REVISED TECHNICAL SPECIFICATIONS

860407006B 860402
PDR ADOCK 05000261
P PDR

(1) CORPORATE REORGANIZATION
REVISED TS PAGES

FACILITY ORGANIZATION
ROBINSON NUCLEAR PROJECT
Figure 6.2-2

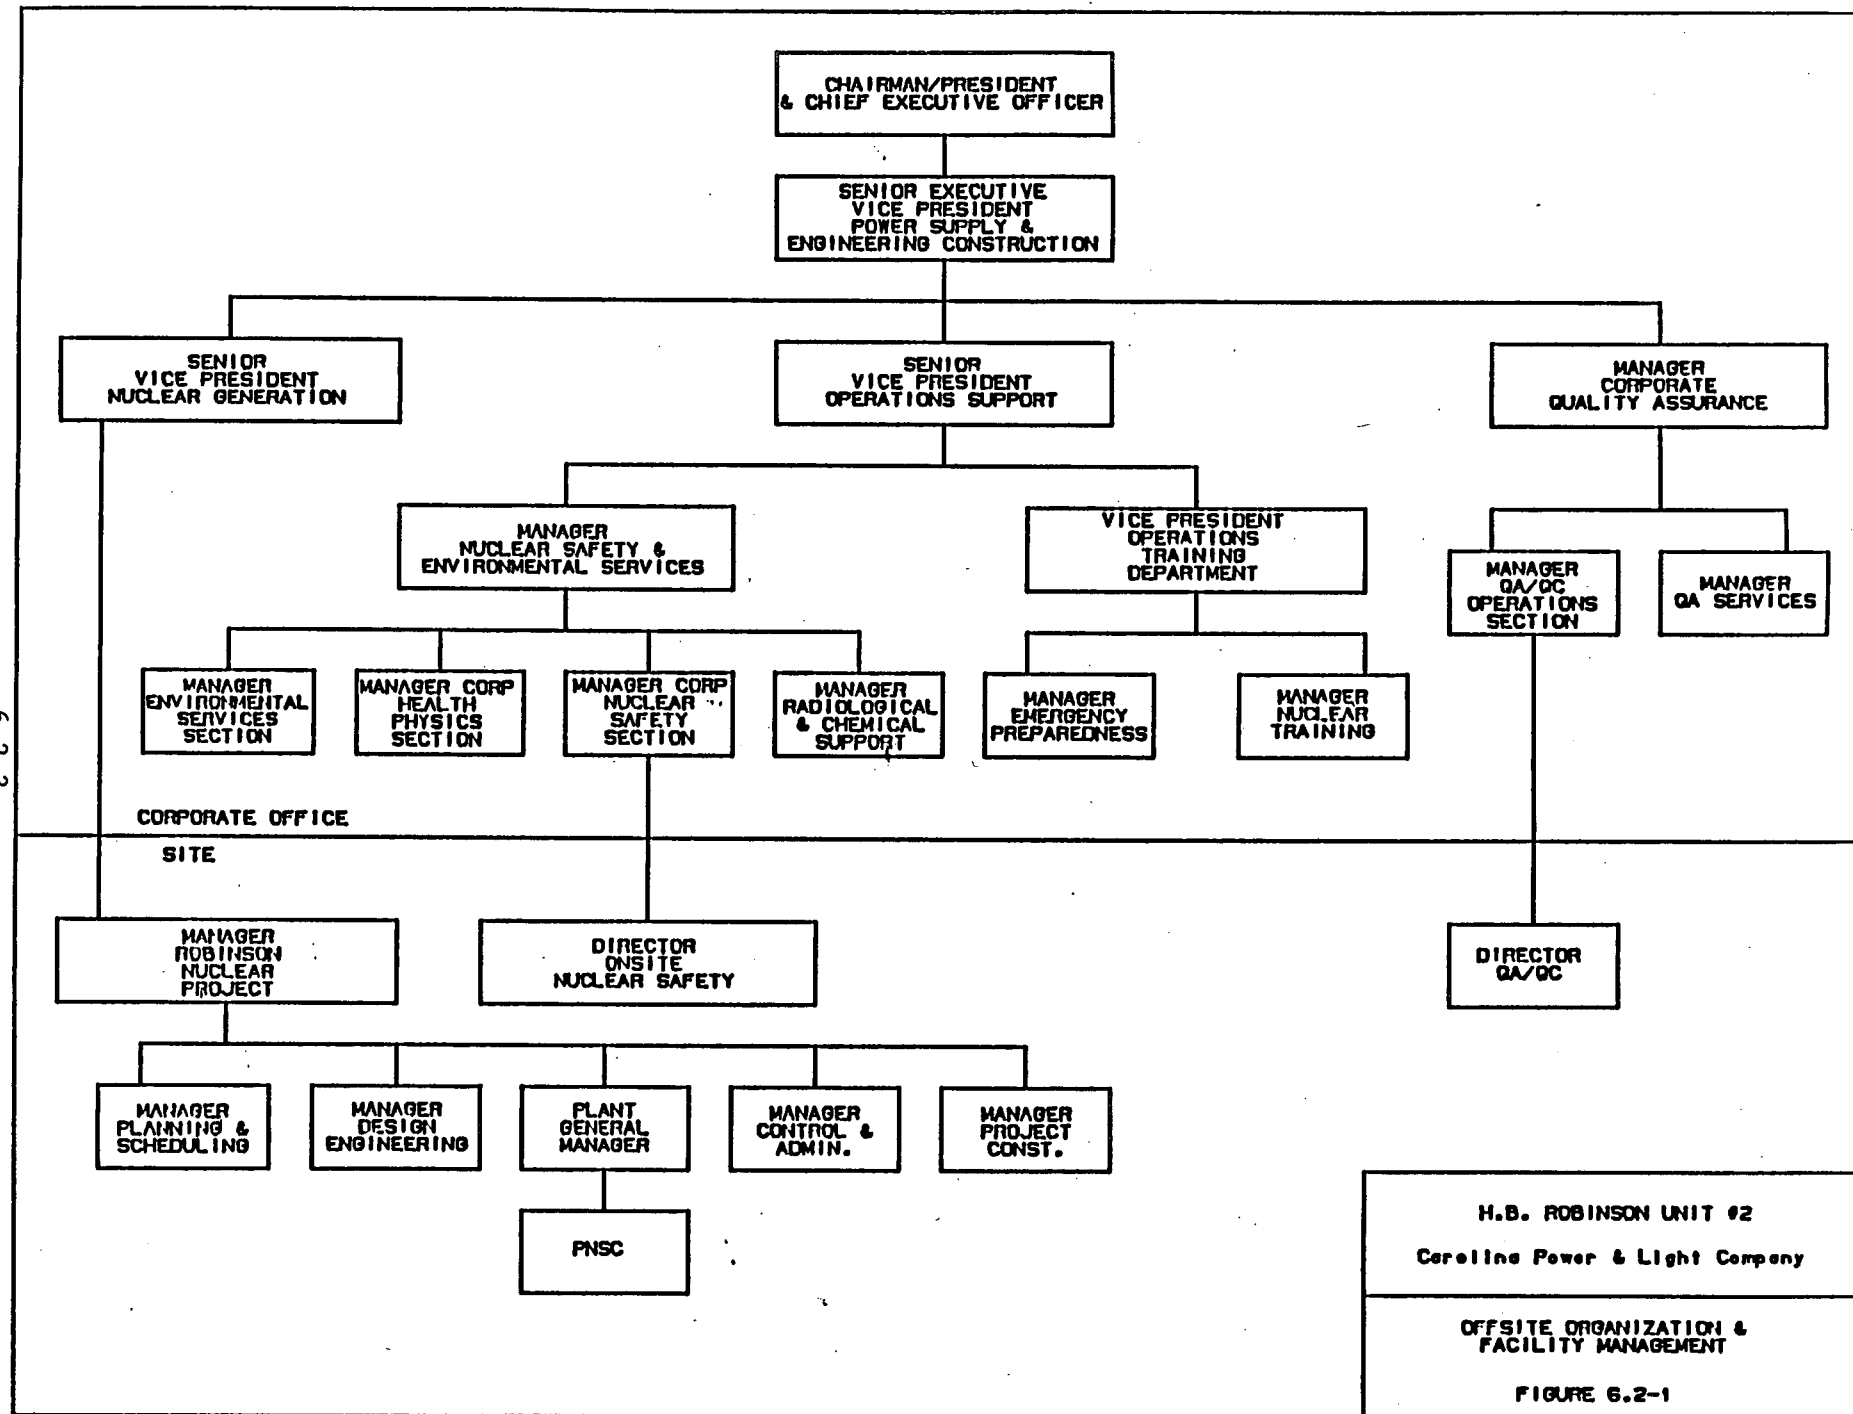
- 6.2.3 The Robinson Nuclear Project organization shall be as shown in Figure 6.2-2 and:

(2) POSITION TITLE CHANGE
